UNITED STATES PATENT AND TRADEMARK OFFICE

APPLICATION NO.	FILING DATE	FIRST NAMED INVENTOR	ATTORNEY DOCKET NO.	CONFIRMATION NO.
10/679,570	10/06/2003	Alexander Heilig	TRW(REPA)6762	3141

Office Action Summary

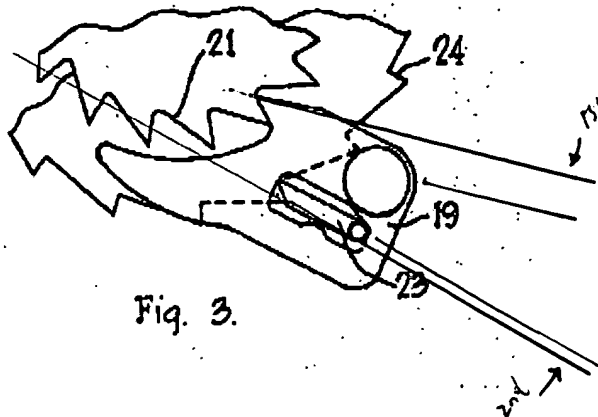
With respect to claims 1, 5 and 9, Heath '068 shows a frame (12) and a belt spool (28) mounted in said frame; first and second locking wheels (21, 24) and first and second locking catch (20, 23) engaging respectively and spaced apart (claim 2) able to position into non-locking and locking modes, and a spring (32, see figures 8-10, rotating each disc together and the disk contains first and second wheels) is provided (claim 8), each locking catch has a point of rotation (no reference numbers) and able to swing perpendicularly on each tooth face respectively (no reference numbers) from the point of contact, and the first locking catch (20) runs between said point of rotation and a rotation axis of said belt spool (28), and the second locking catch (23) runs on the side of point of rotation facing away from said rotation axis of said belt spool (28), see figure 1.

With respect to claims 6-7, Heath '646 shows each locking wheel and each locking catch with a different cut (i.e. the teeth for each wheel, as well as each locking catch has its own respective pitch or cut), see figure 1.
